DESIGN REVIEW BOARD

DRB2014-23

Design review for partial exterior renovation

1020 17TH ST S - EIGHT BALL POOL HALL

EXHIBIT C - PROPOSED EAST ELEVATION

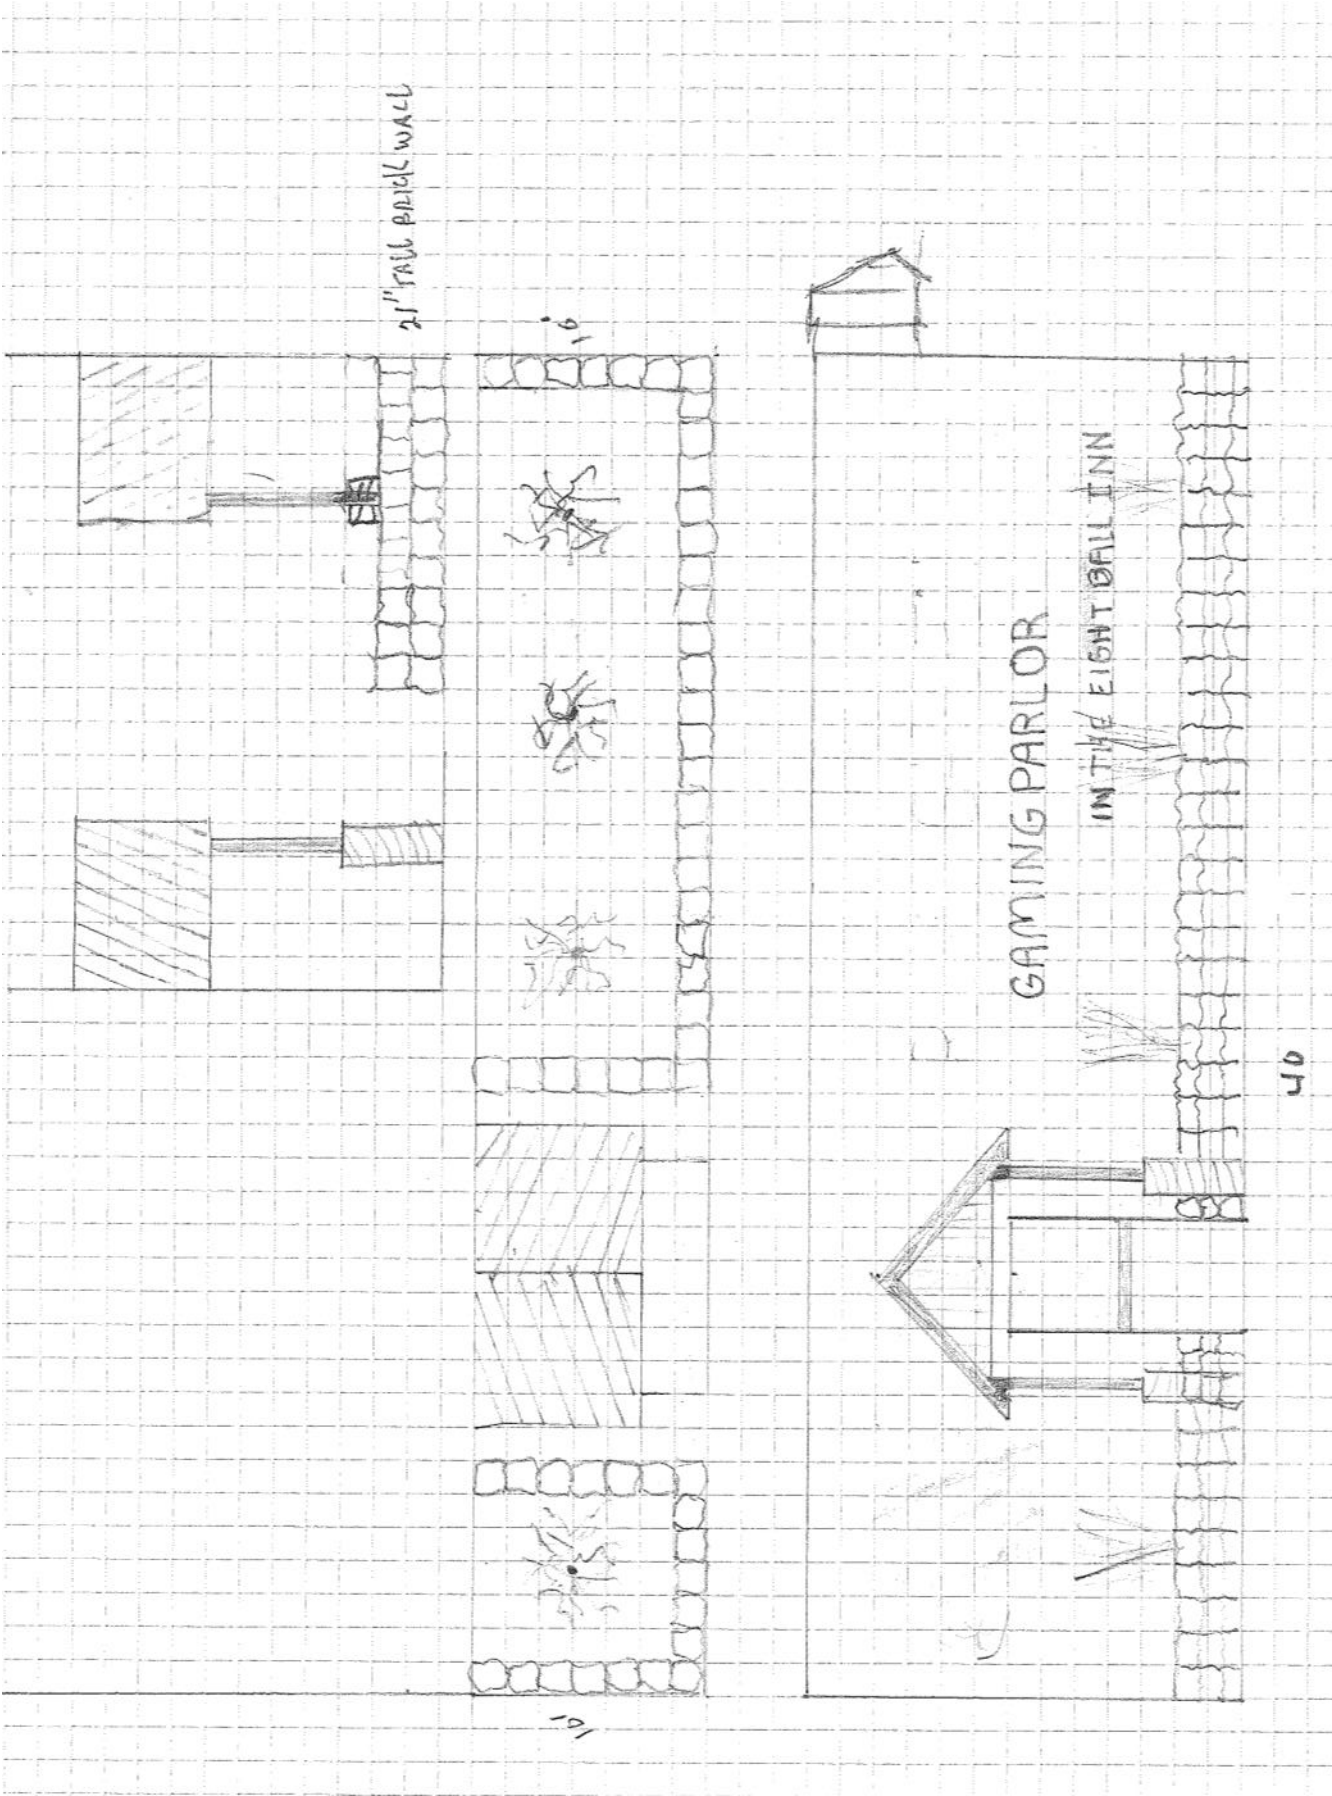
The existing nonconforming structure is located at 1020 17th Street South and previously housed the 8 Ball In. The proposed exterior renovations include upgrading the east façade with new portico that will replace the existing metal door and sign awning. There is a 21-inch brick wall proposed for a foundation planting bed adjacent to each side of the new portico. A portion of the building has a cedar shake awning, which will be replaced with a metal awning.

The 21-inch brick wall proposed for a foundation planting bed adjacent to each side of the new portico shall be at least four (4) feet wide, mulched, and contain a mix of vegetation types (annual flowers, perennial flowers, ground cover and shrubs) per Title 17 landscaping requirements. Additionally, the applicant shall plant boulevard trees along both 17th Street South and 11th Avenue South. The proposed project will take advantage of the existing street and building lights, and is not proposing new lighting. The existing parking lot shall be restriped as part of this project, providing at least 2 accessible spaces.

- C. The 21-inch brick wall proposed for a foundation planting bed adjacent to each side of the new portico shall be at least four (4) feet wide, mulched, and contain a mix of vegetation types (annual flowers, perennial flowers, ground cover and shrubs) per Title 17 landscaping requirements. Additionally, the applicant shall plant boulevard trees along both 17th Street South and 11th Avenue South.
